# DCPL New Lamond-Riggs Library

Commission of Fine Arts Presentation - Final

April 16, 2020

# Project Review Comments (Concept - 1/16/2020)

# Building Materials Concept (1/16/2020)

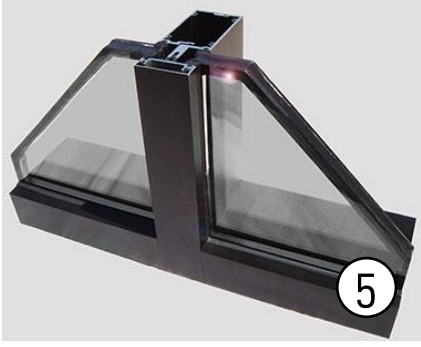
*CFA Comment: Commissioners commented on the "many materials and details of the building exterior."*

# Documentation of Perforated Screen

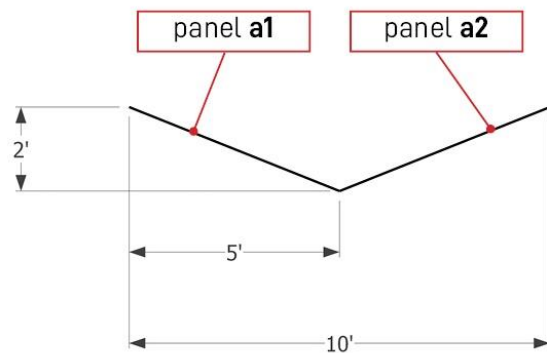
*CFA Comment: Commissioners requested additional documentation of the proposed exterior screen.*

*Response: Example of perforations at exterior screen, ranging from 1/2" to 2" in diameter, depending on patterning of individual panel*

# Site Proposed Landscape Plan

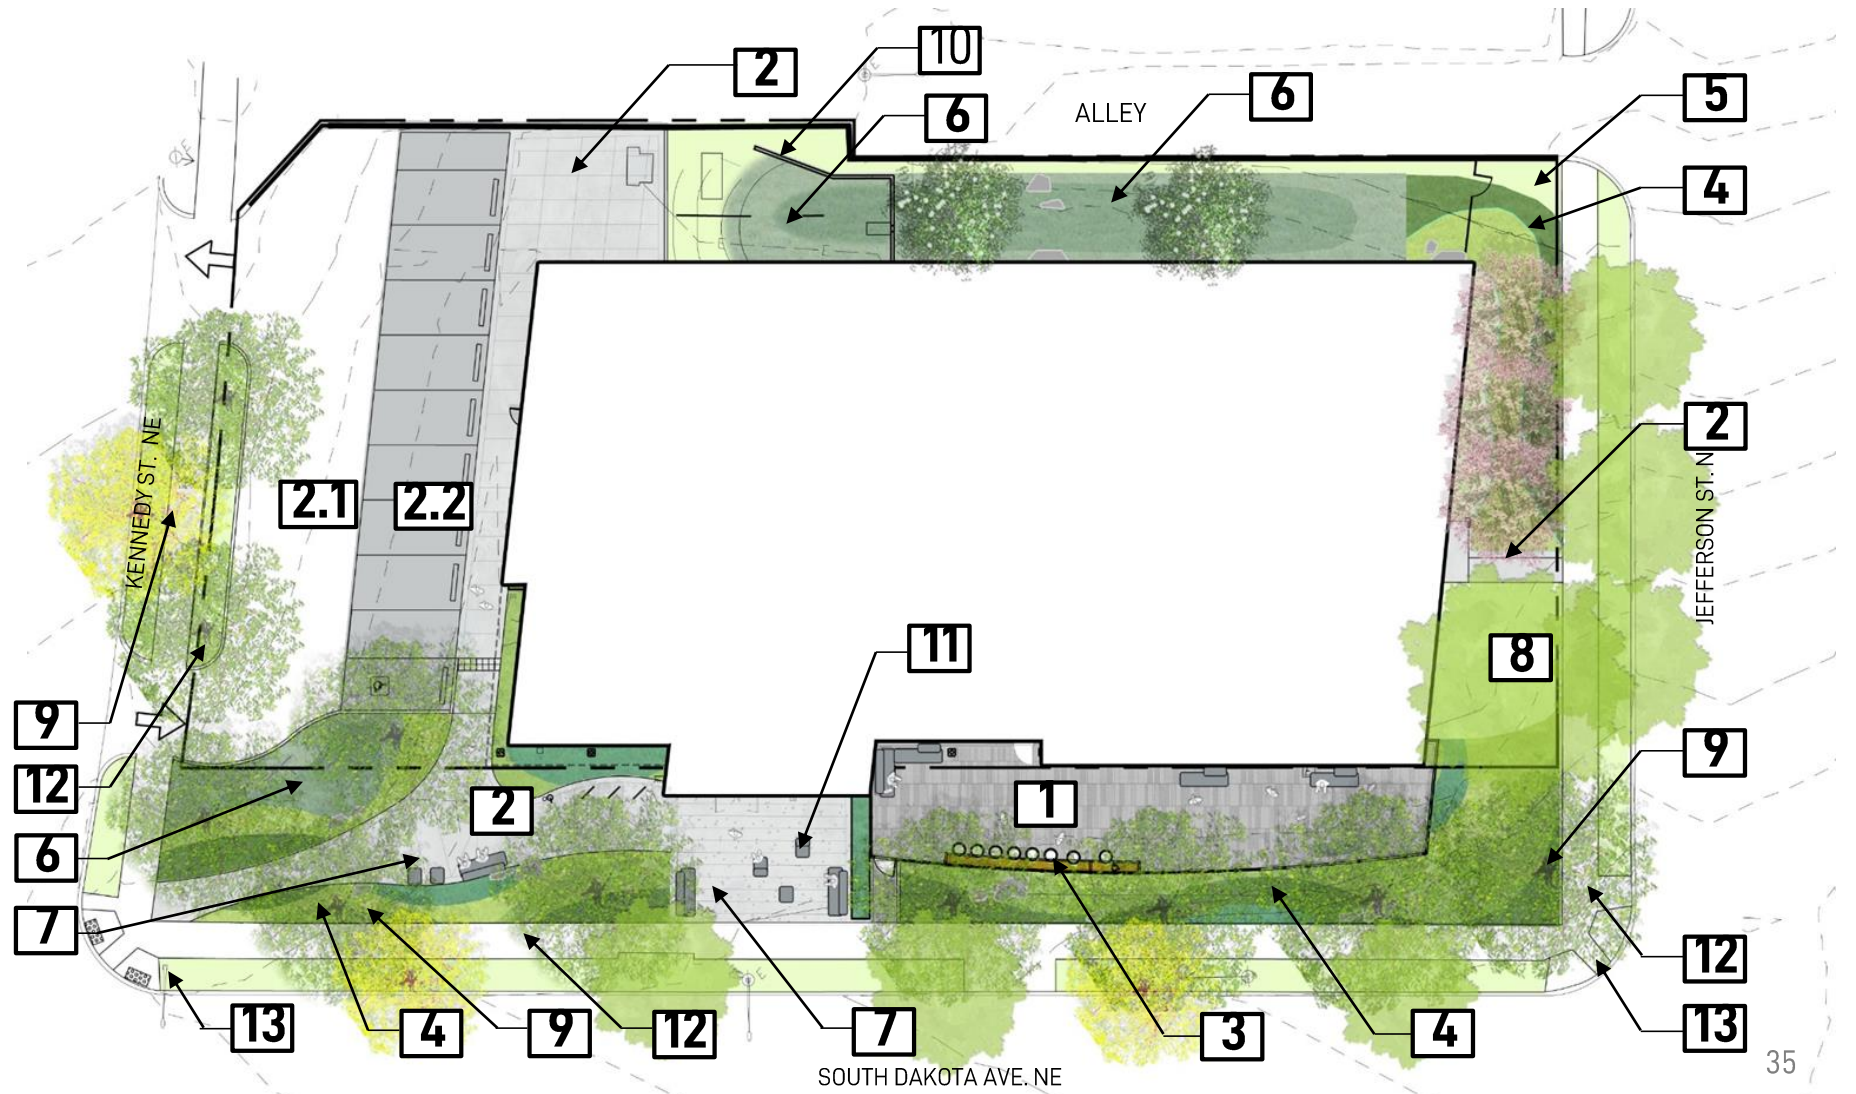
*CFA Comments: Commissioners suggested [parking lot] could be pervious and be reconfigured...[include] additional plantings such as shade trees near this corner...[simplify] the proposed material palette to bring additional continuity to the ground plane and furnishings*

*Response: Parking spaces shifted towards the back of the building to accommodate a larger planting area at the front corner of the building. This planting area also treats stormwater runoff from Kennedy Street. Parking spaces are now poured-in-place concrete flush to the concrete sidewalk, creating an entrance plaza. A bioretention area at the back of the building captures and treats runoff from the parking area.*

## Site Shading of Outdoor Seating Area (Concept)

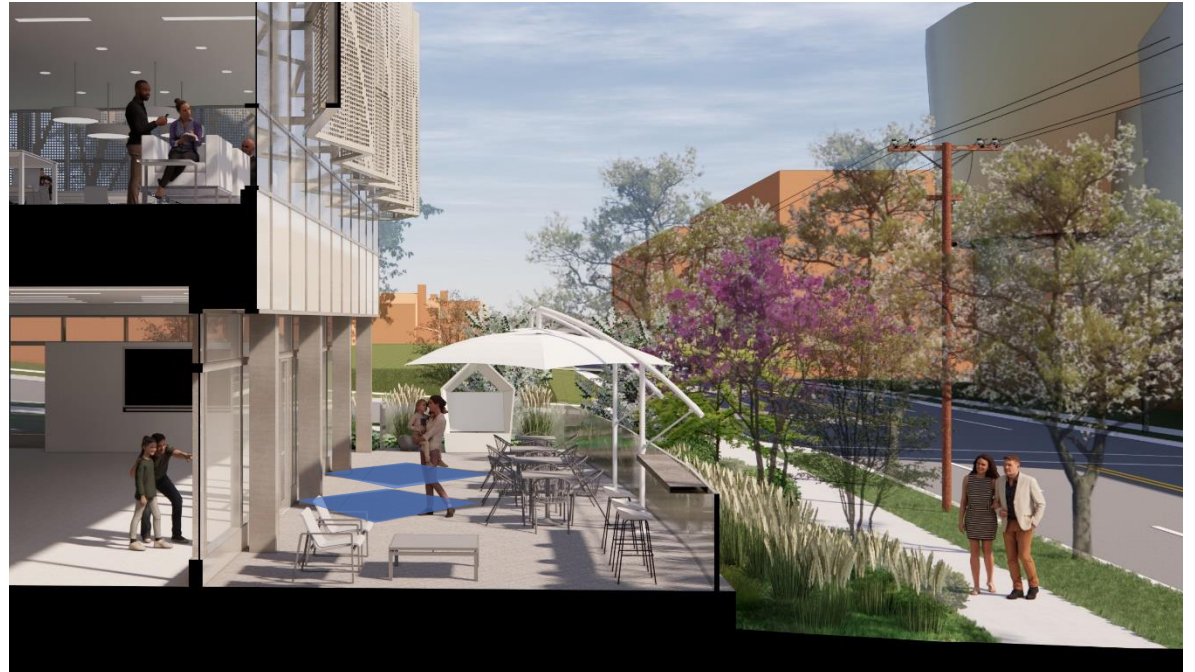
*CFA Comment:* Commissioners noted that front porch is exposed to low south/southwest sun and requested the design team to explore approaches to provide shading in this area.

*Response 1 (Bottom Left): The design team explored extruding the canopy currently at the entry vestibule into the "front porch". However, if extruded to same dimension, canopy will provide limited shade relief to porch occupants. Canopy also extends into public space requiring additional public review. The team does not recommend this solution.*

*Response 2 (Bottom Right): In lieu of a permanent shading device (e.g. canopy), the team explored using a temporary/removable seasonal shading fixtures at porch. The team does not recommend this out of concern that fixtures are too informal for South Dakota Avenue.*

# Site Abstract Tree Concept / Plant Additional Trees

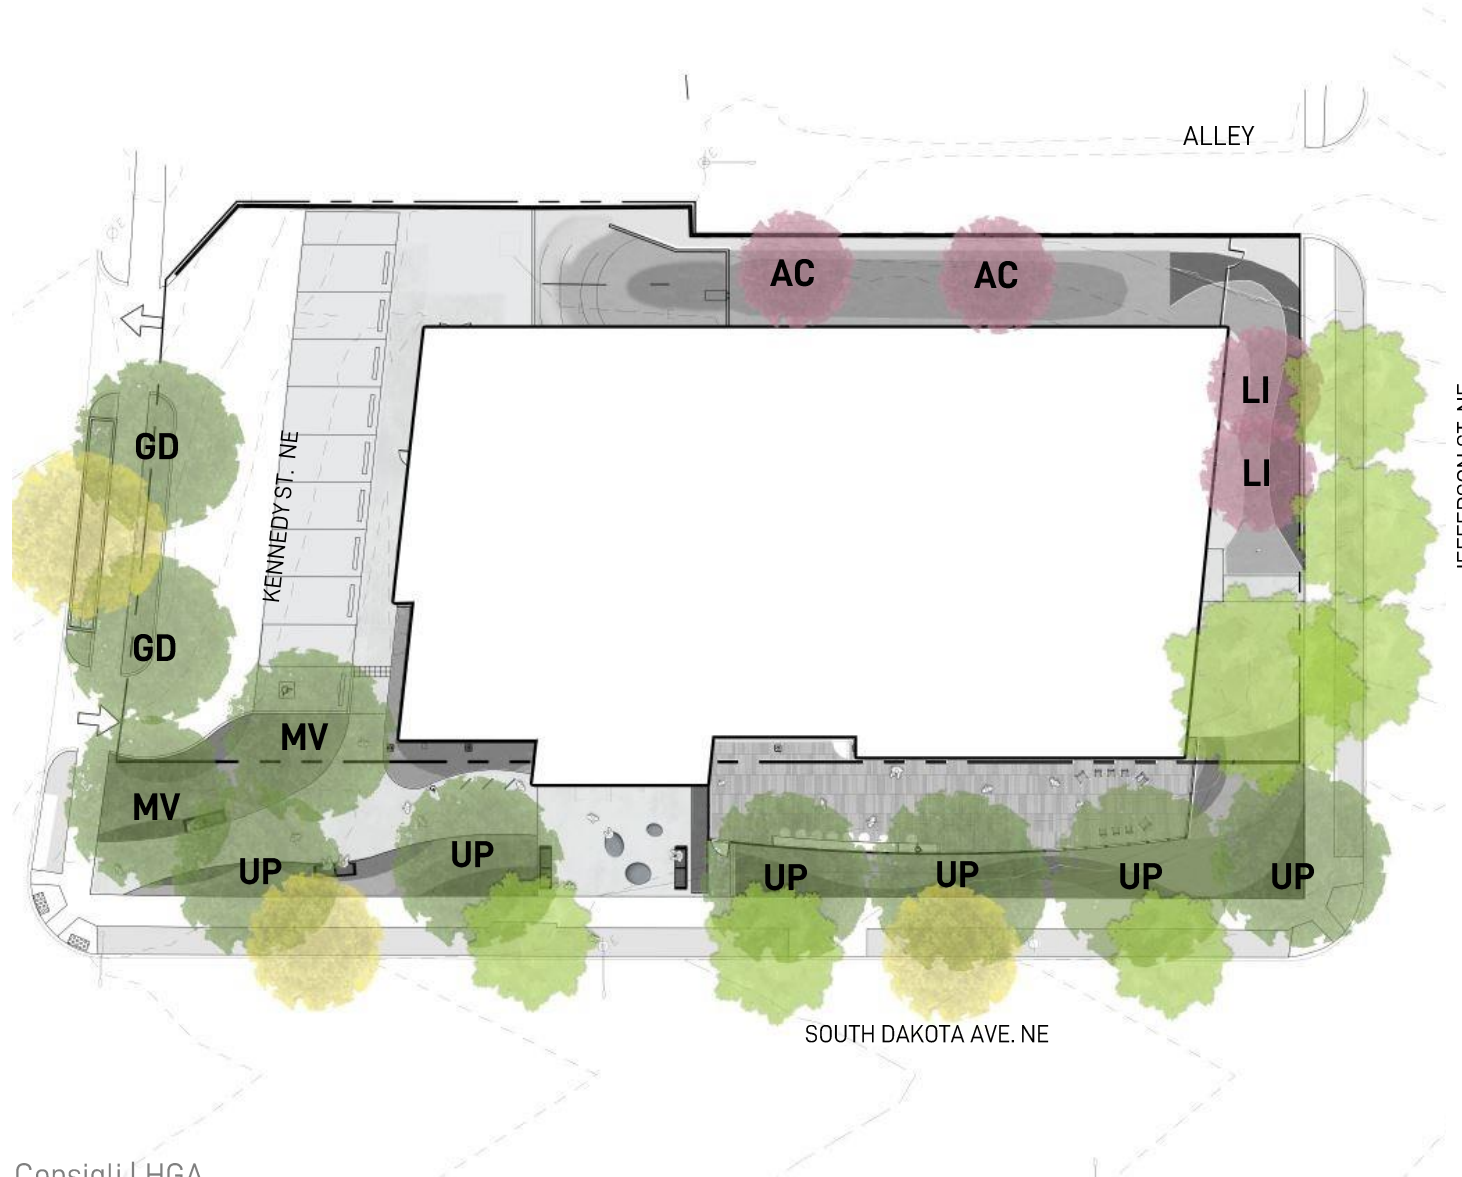
CFA Comment: Commissioners suggested the "...inclusion of additional plantings, such as shade trees, near this corner...questioned the retention of the existing pear tree"

Response: Additional tree canopy is provided around the building with larger canopy trees planted along South Dakota Avenue to provide additional shade. The existing Pear tree will be preserved.

Existing Pear Tree to be preserved for spring color and corer prominence.
